INDESIT company

Model type:
IDC75UK

Commercial code:
F062939

07427-20 Exploded views

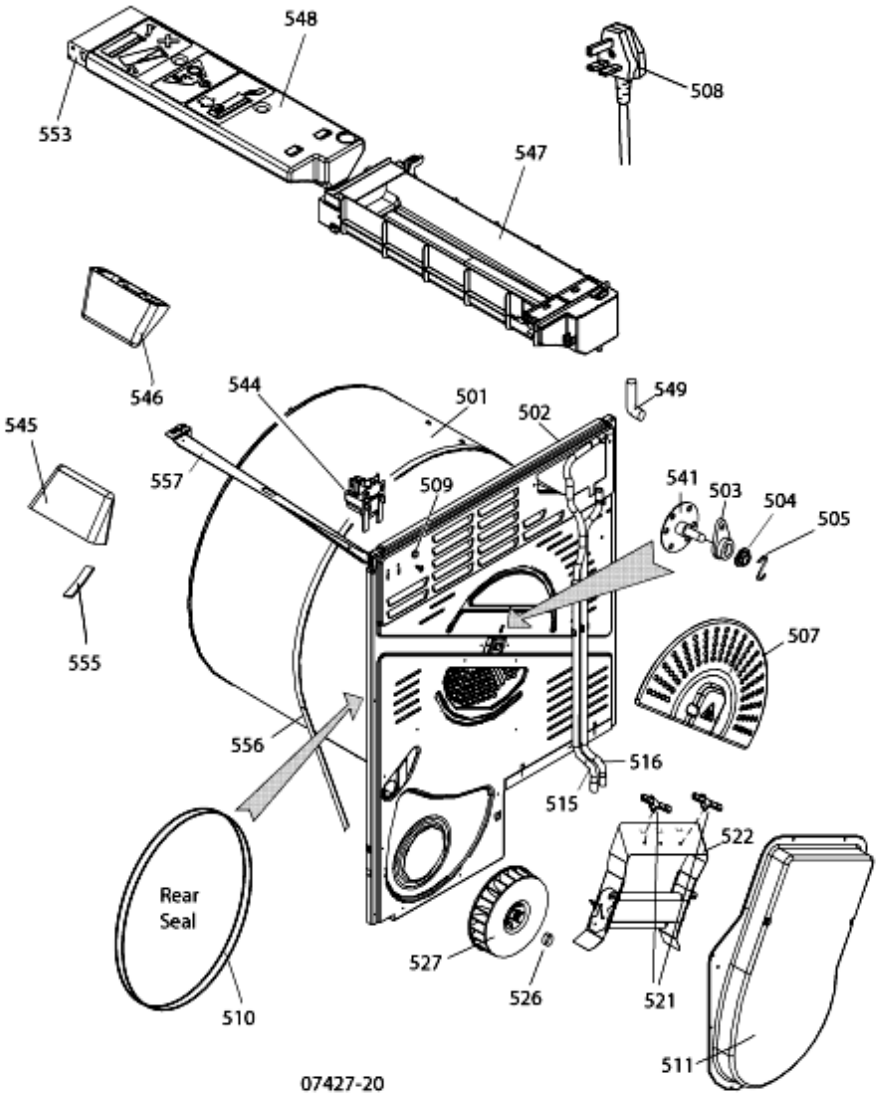
n4411j00: PATTERN DRUM INTRODUCED

FROM OCTOBER 2011 A PATTERN DRUM HAS BEEN USED IN PRODUCTION.
THE PATTERN DRUM IS INTERCHANGABLE WITH THE PREVIOUS PLAIN DRUM.
ONCE STOCKS OF THE PLAIN DRUM ARE EXHAUSTED.
THE PATTERN DRUM WILL BE THE SERVICE SPARE.

NOTE
TWO PLAIN DRUMS WERE USED IN PRODUCTION.
THE DRUM SHAFT CAN ONLY BE REPLACED IF THE ORIGINAL DRUM TO SHAFT FIXING IS SCREWED. IF THE DRUM SHAFT IS RIVETED TO THE DRUM, THE COMPLETE DRUM HAS TO BE REPLACED.

n4414g00: DRUM SHAFT REPAIR KITS

THERE ARE 2 TUMBLE DRYER DRUM SHAFT KITS.

C00113038 DRUMS WHERE THE DRUM SHAFT IS SCREWED
C00305794 DRUMS WHERE THE DRUM SHAFT IS RIVETTED.
THE CORRECT KIT MUST ALWAYS BE FITTED.
BOTH KITS CONSIST OF THE DRUM SHAFT/SUPPORT, DRIVE PIN FIXING SCREWS and REAR BEARING.
STARTING FROM JUNE 2014 THE DRUM SEALS WHICH WERE INCLUDED IN KIT C00113038 HAVE BEEN REMOVED.

n4413j00: BREAKING BELTS

To overcome the issue of breaking belts the 6 Rib belt has been replaced by the 8 rib belt C00300793

07484-05 Exploded views

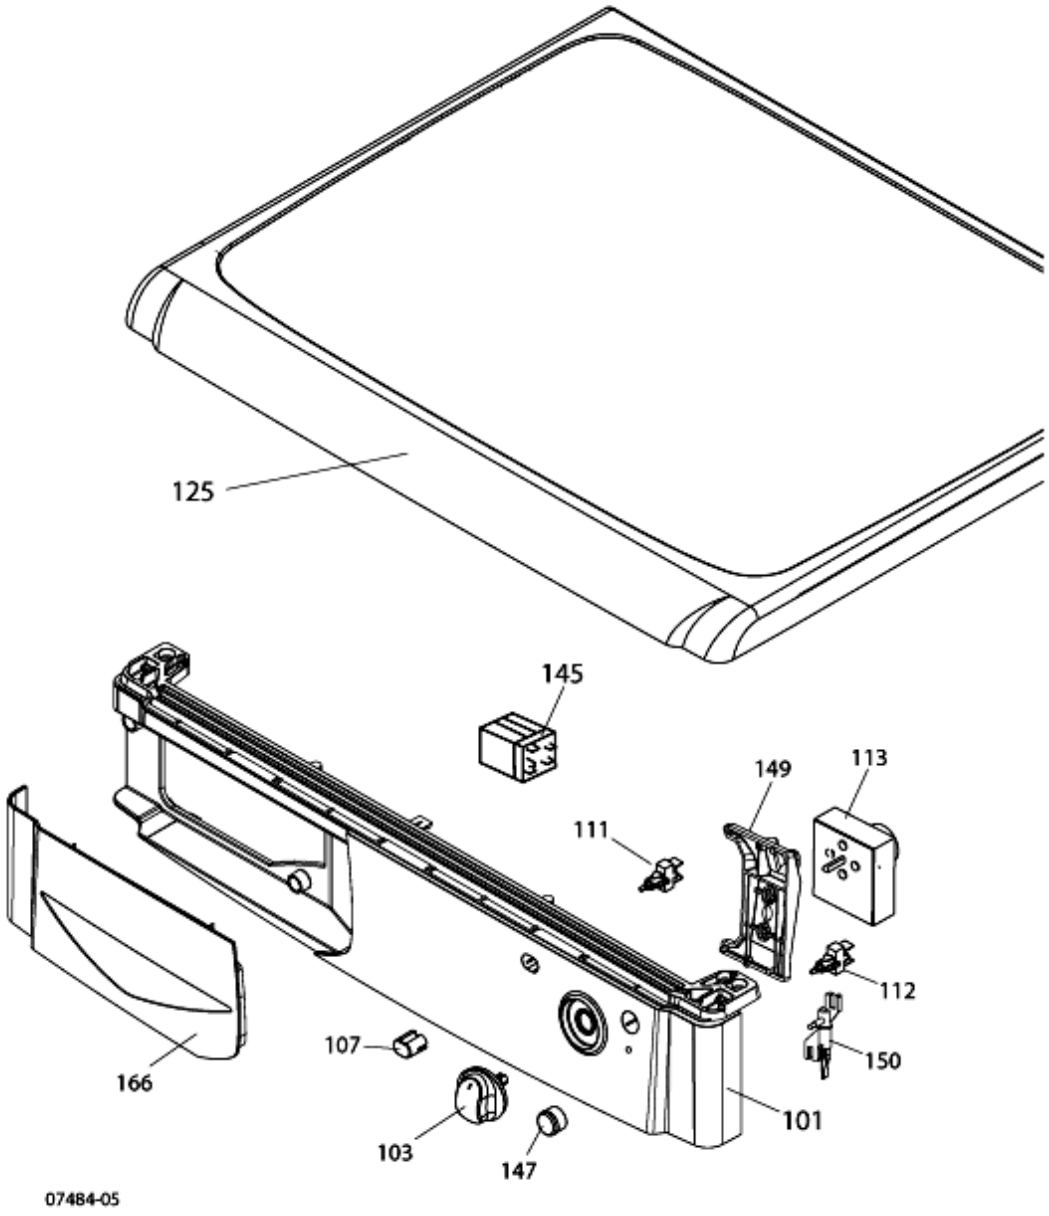
n4410a00: Alternative Build 19/01/10

On 19/01/10 a quantity of 32 model IDC75P Tumble Dryers were built usung the Console, Relay & Door Micrswitch from the export version IDC75EU commercial code 62979.
The tumble dryer function is not effected other than by using a relay to operate the door switch to start the product.

12721-15 Exploded views

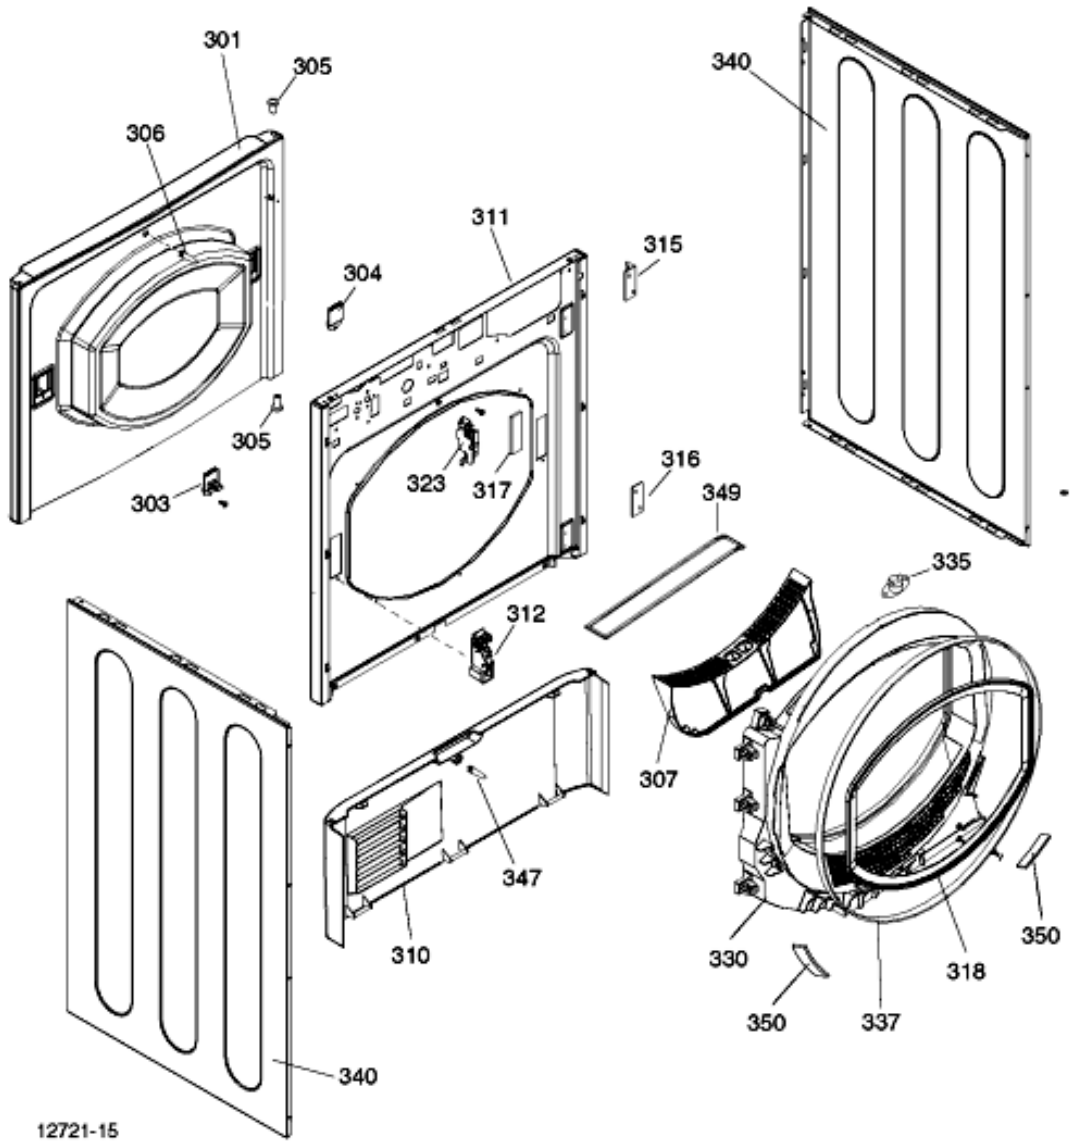
n4409i01: Bearing Pad Grooved

'C' Energy Condenser Tumble Dryers.
From serial number 90817.0001 the quantity of bearing pads C00255284 fitted on production was reduced fro 5 to 4.
'B' Energy Condenser Tumble Dryers are not effected and will continue to use 5 bearing pads

n4411g07: CONDENSER FRONT AIR DUCT COLOUR CHANGE

FROM JUNE 2011 THE FRONT AIR DUCT FITTED TO CONDENSER TUMBLE DRYERS CHANGED IN PRODUCTION FROM GREY TO WHITE.
SELECTED THE CORRECT PART BY DESCRIPTION IN THE PARTS LIST

n4414b01: CONDENSER MECHANICAL DRYER FRONT THERMOSTAT

FROM JULY 2013 THE FRONT AIR DUCT THERMOSTAT IS NO LONGER USED IN PRODUCTION>

12721-25 Exploded views

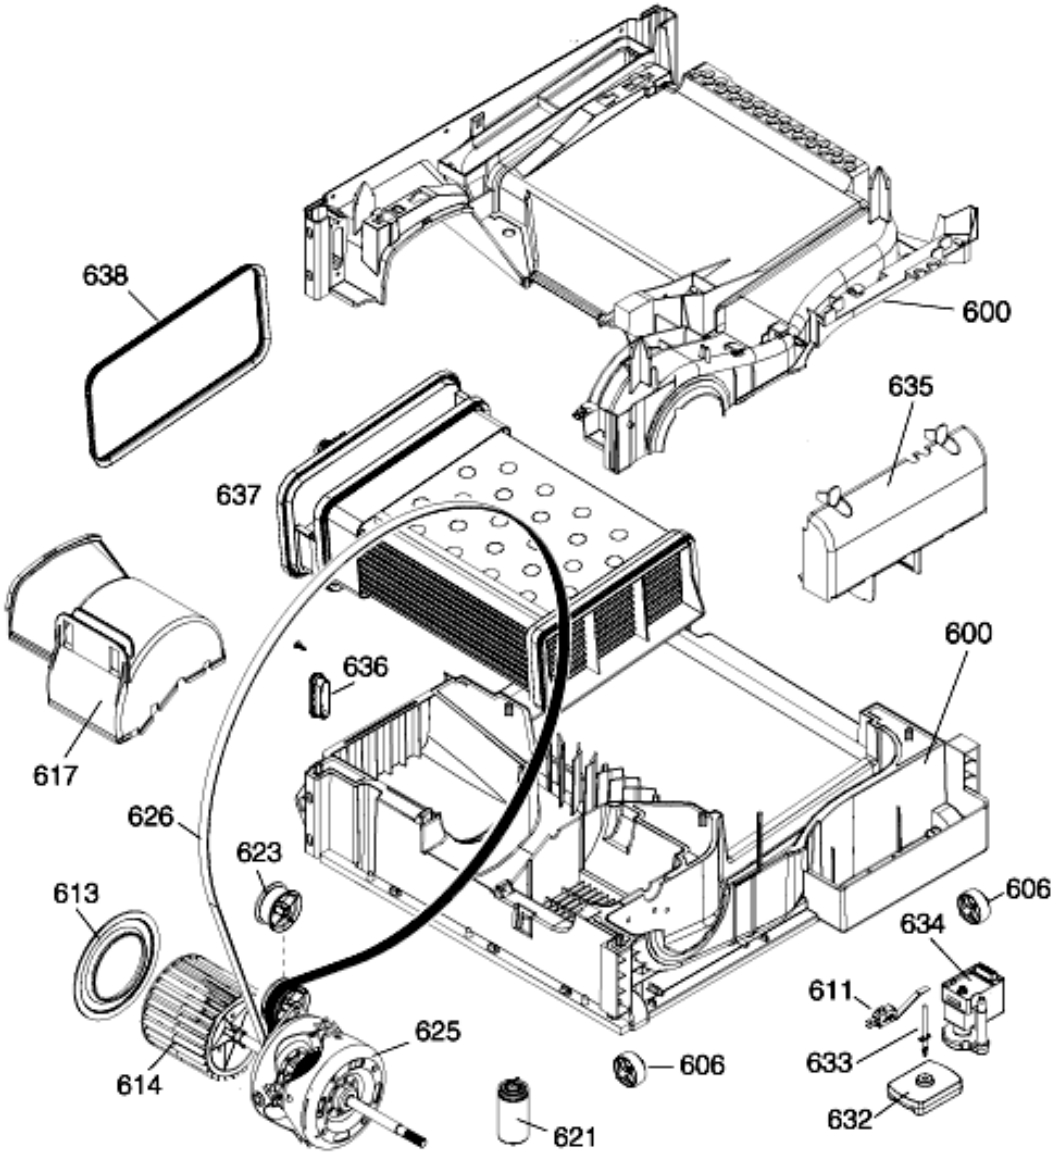
n4414a0a: CAPACITORS CONDENSER DRYERS

THE CORRECT SIZE CAPACITOR MUST ALWAYS BE USED.

356 MOTOR	9.5uf CAPACITOR
364 MOTOR	8uf CAPACITOR
351 MOTOR	8uf CAPACITOR
392/363 MOTOR	8.5uf CAPACITOR
365/366 MOTOR	9.5uf CAPACITOR
